**BLAINE COUNTY
LAND USE AND BUILDING SERVICES**

To: Blaine County Commissioners

From: Allison Kennedy, Planner II

Re: Quigley Ranch Subdivision Hearing

Image: Quigley Farm Large Block Plat Block 15 Source: Blaine County GIS

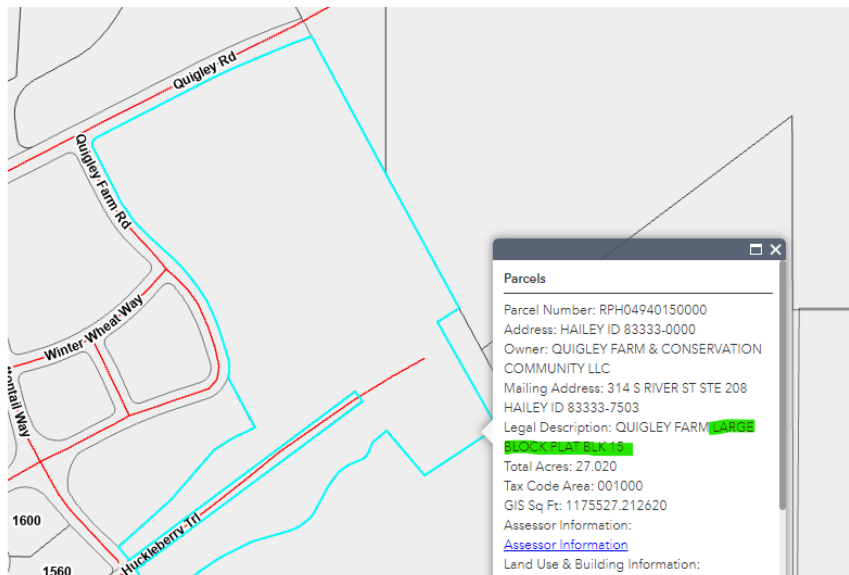
The Planning & Zoning Commission discussed the preference of the development being accessed through the adjacent City of Hailey Quigley Farm Subdivision to best meet the subdivision standards. While Quigley Road is the existing county road, an additional city access option may be possible, since this land area is an undivided block and not individual lots. In addition, the City of Hailey Community Development Director has expressed verbally that they are open to this idea of revising the plat to extend a street to Quigley Ranch. If the Board decides to move forward with this recommendation, the application could be tabled until this option is vetted with the City of Hailey’s City Council and Community Development Department.
